(Comanche Peak Steam Electric Station
Station, Units 1 and 2)

CASE'S ANSWER TO APPLICANTS' REPLY TO CASE'S ANSWER TO
APPLICANTS' MOTION FOR SUMMARY DISPOSITION
REGARDING LOCAL DISPLACEMENTS AND STRESSES

AFFIDAVIT OF CASE WITNESS JACK DOYLE

Attached to this Affidavit is Attachment D which includes two sketches: Sketch 1 is of the RHR pipe with a thickness of 1.0 inch and indefinite diameter disc welded all around. Sketch 2 depicts the RHR pipe with a box frame and represents the conditions as they exist in the real world.

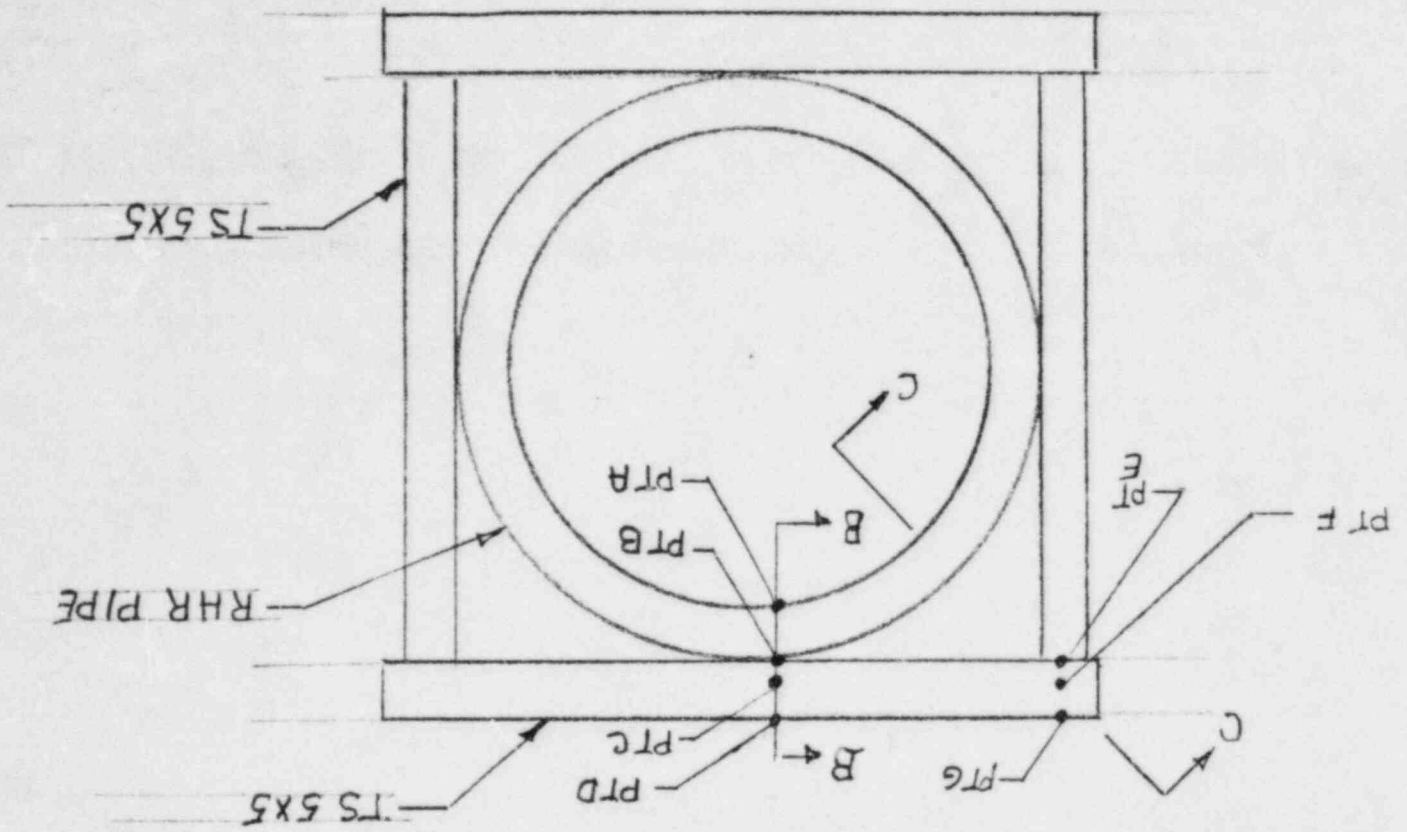
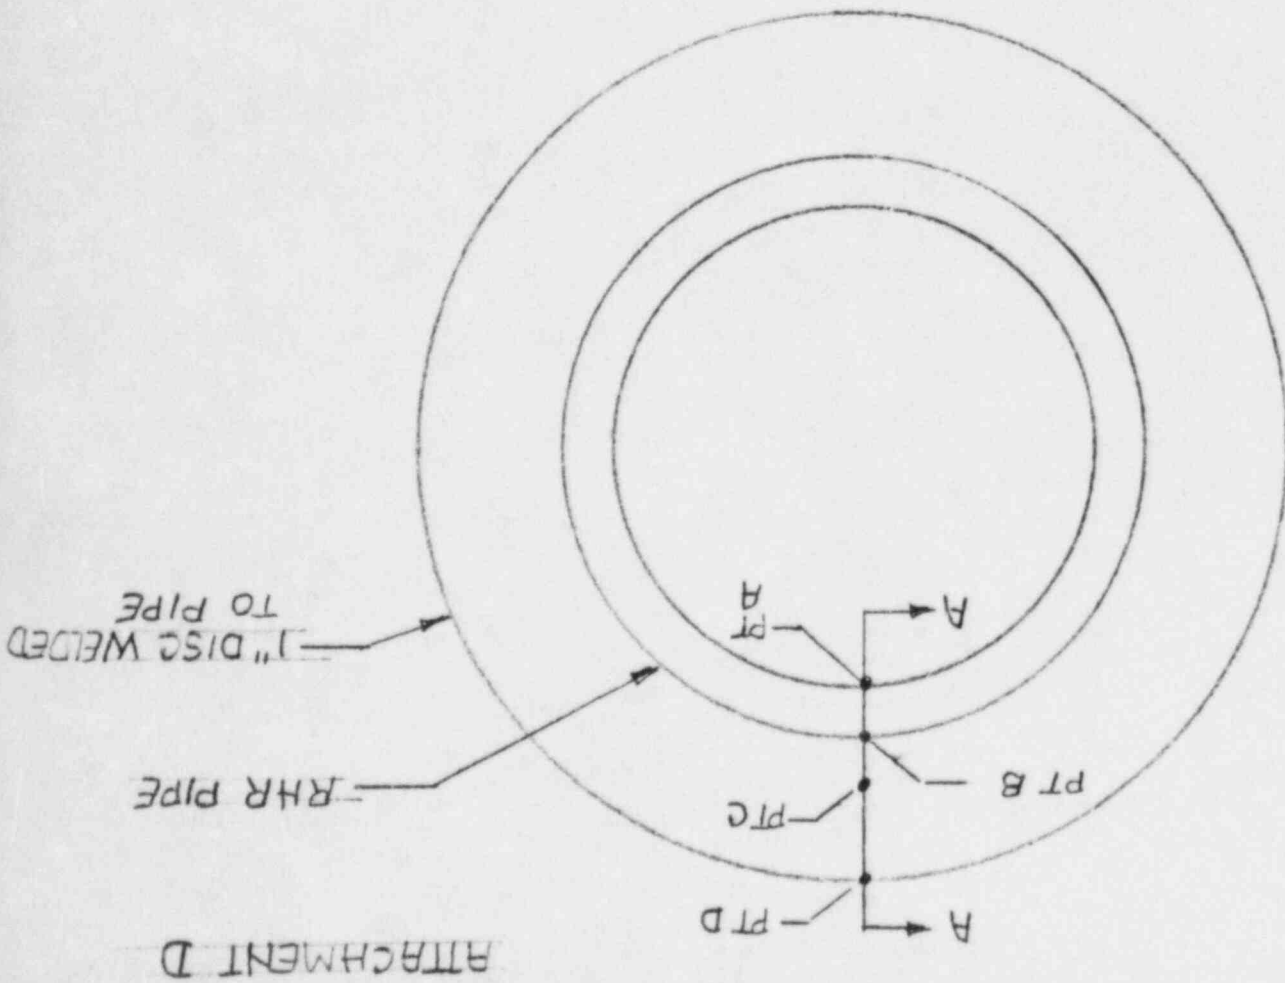
The temperature for PT A for either Sketch 1 or 2 of my Attachment D would be 350 degrees F., the average temperature (no PT given) in either Sketch 1 or 2 would be 326 degrees, the temperature for PT B in either Sketch 1 or 2 would be 302 degrees F., the average temperature for PT C in either Sketch 1 or 2 would be 203 degrees F., the temperature for PT D in either Sketch 1 or 2 would be 104 degrees F.

Now with everything of consequence transferred to the sketches in my Attachment D, we can proceed. As can be seen, we agree that the method of determining the temperatures by Applicants' procedures would have the same values for Plane A-A in Sketch 1 or Plane B-B in Sketch 2. The divergence from reality occurs when we depart from Plane A-A or B-B.

Referring to Sketch 1, if we take any radial plane similar to Plane A-A, the values for corresponding PT's (similar to those at A-A) would be the same at PT's A, B, C, and D on Plane A-A.

Referring now to Sketch 2, it is obvious that any radial plane within a quadrant, C-C for example, would not be represented by the values as calculated by Applicants as shown in the section view of Applicants' Attachment A, page 1.

Any conductive increase in temperature at the frame corners can only result from thermal transport due to the temperatures at PT's B, C, and D, and will be something less than 302 degrees and 203 degrees. (The 104 degrees would obviously be constant); this is because the only

source of energy for the box frame is at Point B (4 places).

The temperature range at PT E plus 2-1/2 inches (at the centerline of the vertical member) would be (using Applicants' first equation from page 1 of Attachment 1):

$$104 + (302-104/13) 2.5 = 142 \text{ degrees F.}$$

. . . and the average temperature for this area is approximately:

$$(142 + 104)/2 = 123 \text{ degrees F. (again using Applicants' methods).}$$

Therefore, the use of 203 degrees F. as the average temperature on which to base the calculations for thermal expansion of the box frame is incorrect and non-conservative.

Carrying Applicants' procedures forward as shown above, and not truncating as Applicants did, shows the average temperature for all cross sections of the box frame combined is not 203 degrees F. as shown by Applicants, but is somewhere between 123 degrees F. and 203 degrees F., about 163 degrees F., and this error is fatal to Applicants' equations from this point on. My argument in my initial Answer to Applicants' Motion did not extend to future analysis, accurate or not, by finite methods (of dubious input technique since we only have a field of numbers and unreadable sketches without interpretation) but only to the calc which we were supplied and for that we find an error of about 20 per cent ($203-163/163$ equals 20 per cent) in determining the critical force used to determine all stresses.

To Summarize: While Applicants' equations on page 1 of Attachment

A may be applicable to Sketch 1 of my Attachment D, they are in no way applicable to Sketch 2.
